CITY OF ALBUQUERQUE

**RE: Lot 18A Block 2 Unit 19 Volcano Cliffs Subd.
7700 Compass Dr. NW
Request for Permanent C.O. - Accepted
Engineers Stamp Date 10/26/15 (D10D003G18A)
Certification Dated: 11/7/16**

7700 Compass Drive, NW Grading & Drainage Certification

GRADING & DRAINAGE PLAN

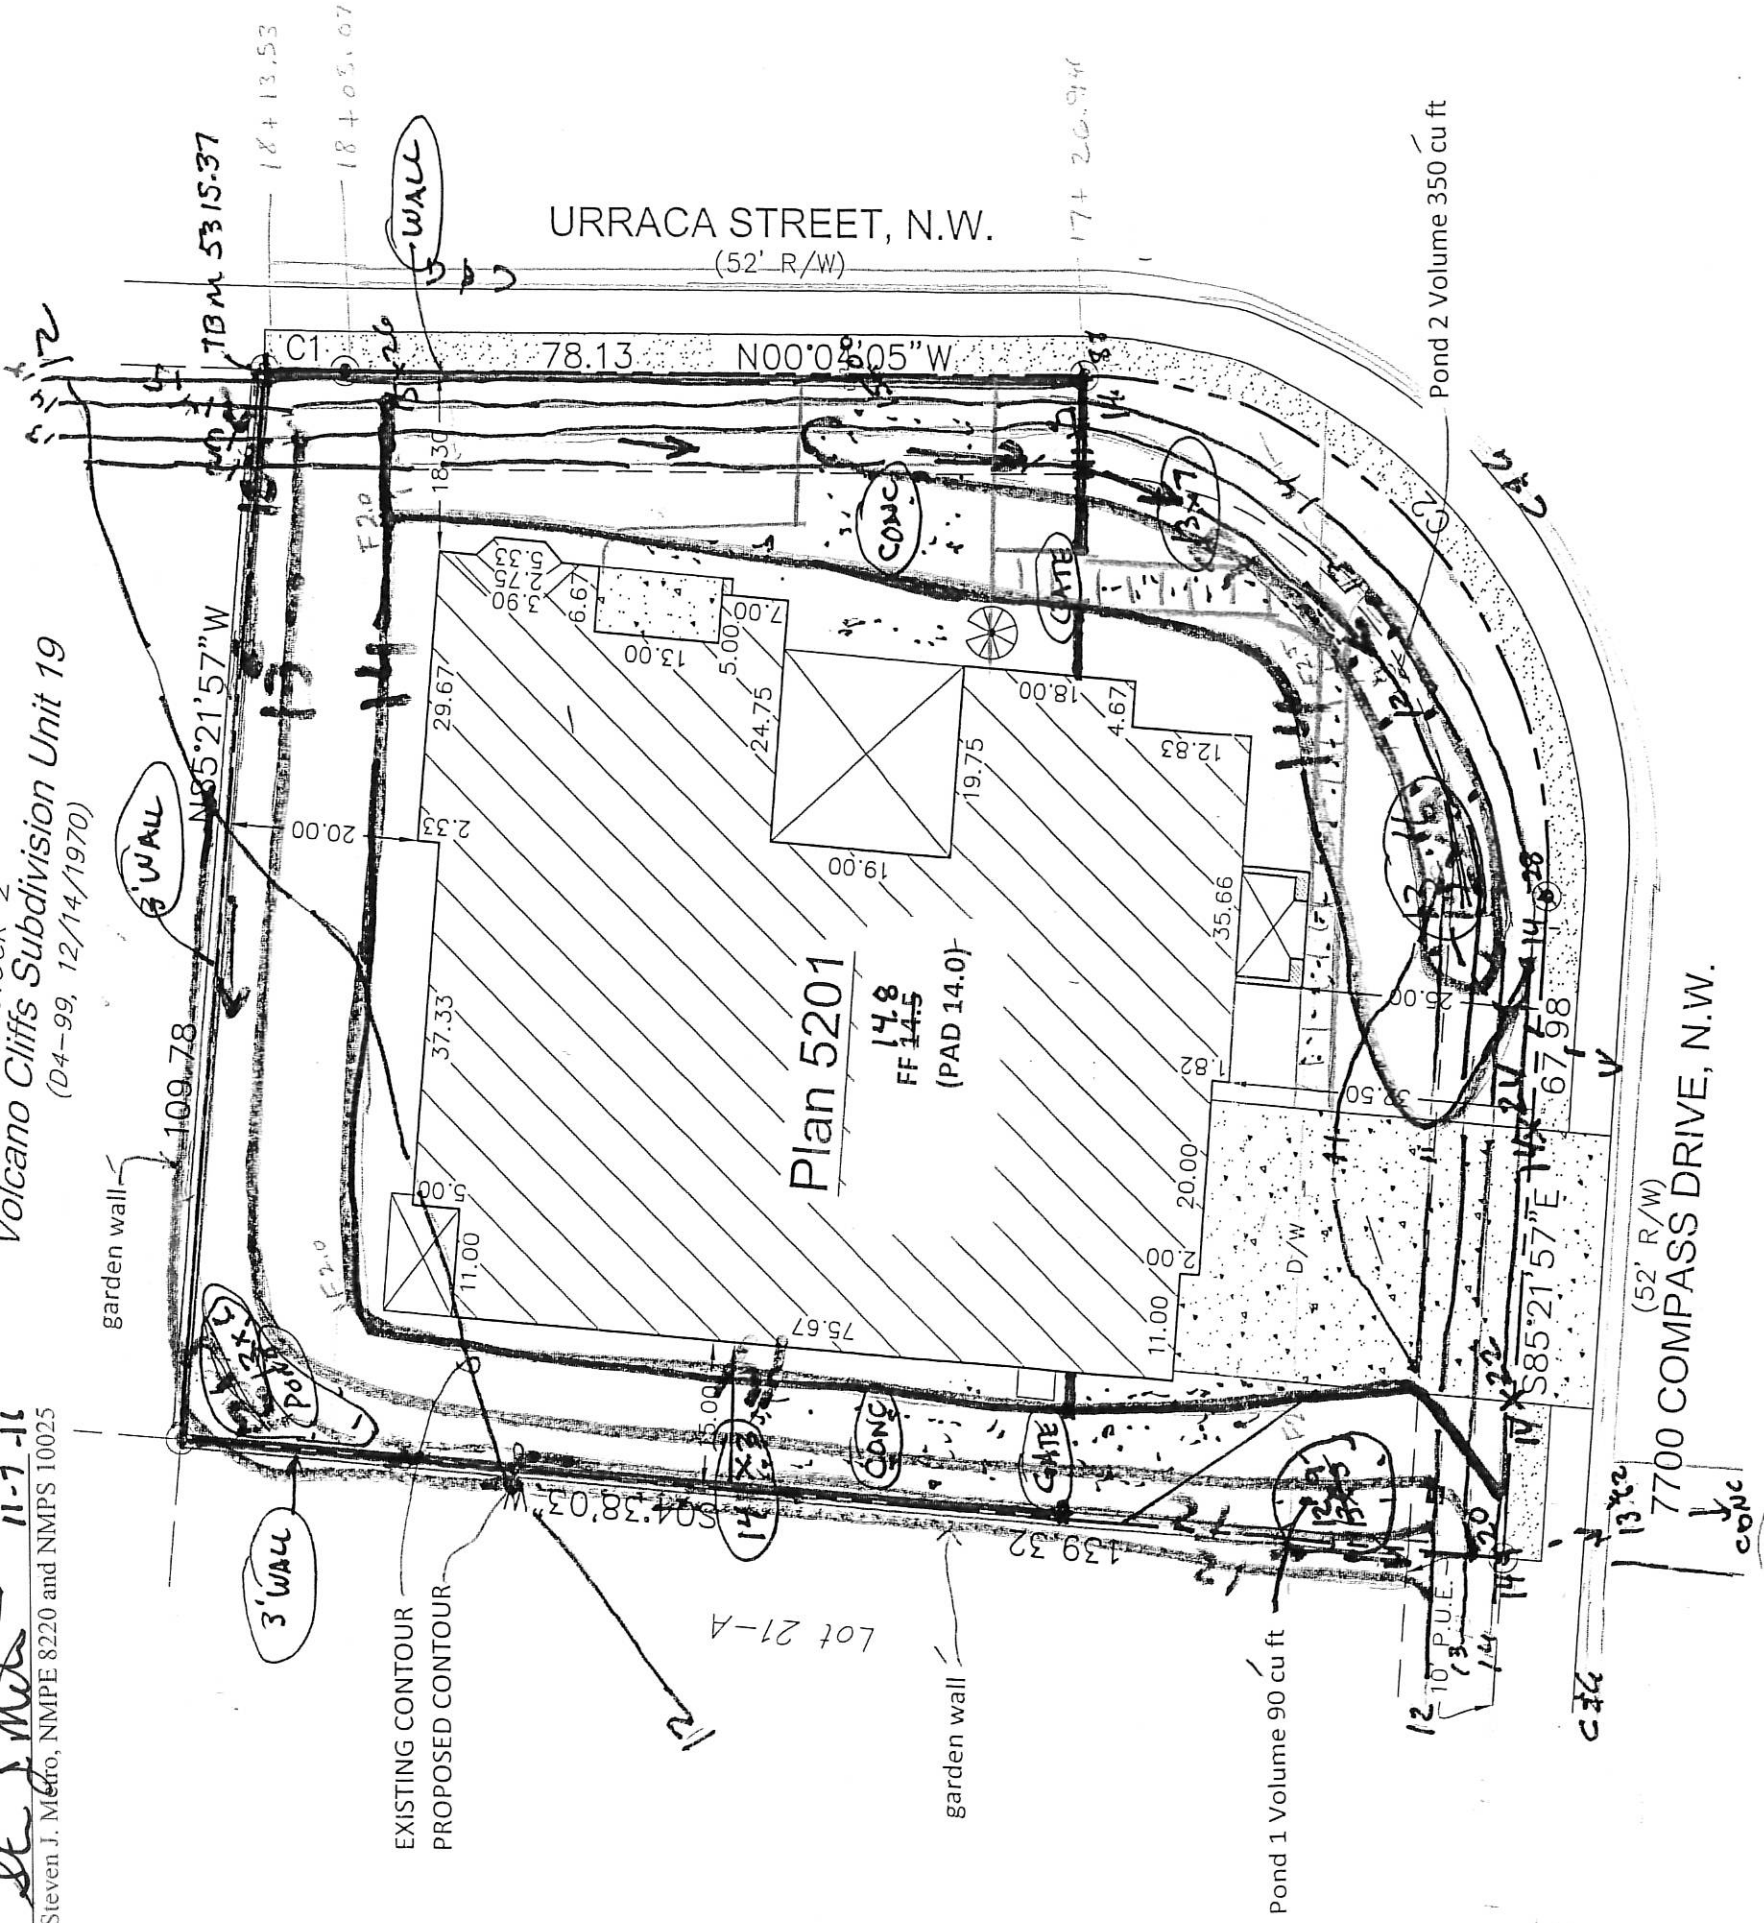
Based on the Certification received 11/7/2016, the above mentioned residence is acceptable for release of Certificate of Occupancy by Hydrology. The pond in the backyard was designed to be further away from the residence. Recommend moving the pond further to the SW corner as indicated on the approved grading and drainage plan.
